Project:  
**415 CUMBERLAND AVENUE**  
 PORTLAND, MAINE

Scale: 1/8" = 1'-0"  
 Date: 12 April 2018  
**ELEVATIONS**

**A2.01**

4 | SOUTH WEST ELEVATION  
 1/8" = 1'-0"

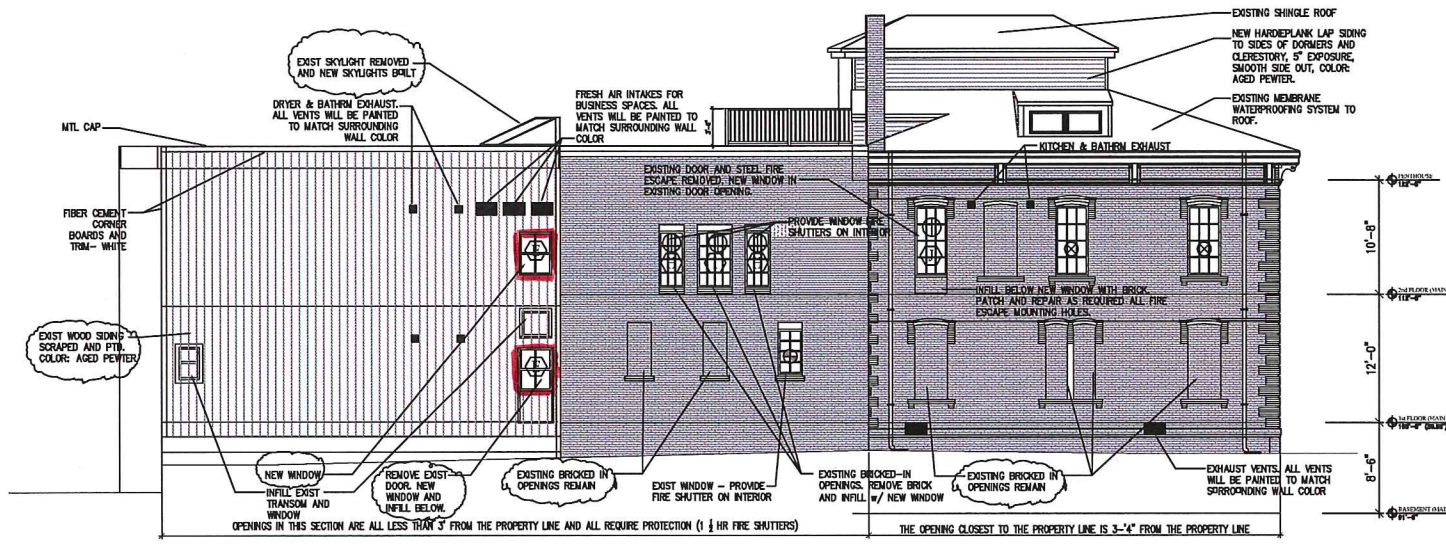
: SHOULD BE ALUMINUM CLAD WINDOW, ALUMINUM FINISHED TO MATCH SIDING (CLOSE IN COLOR).  
 (x 12) REMOVE GRILLE/GRIDS (MAKE 1/1) OR CHOOSE PRODUCT WITH EXTERIOR SIMULATED DIVIDED LITES + SPACERS, GLASS INTERIOR.

: VINYL WINDOW ACCEPTABLE, BUT REMOVE GRILLE/GRID BETWEEN THE GLASS OR CHOOSE PRODUCT WITH EXTERIOR SIMULATED DIVIDED LITES + GLASS INTERIOR SPACERS.
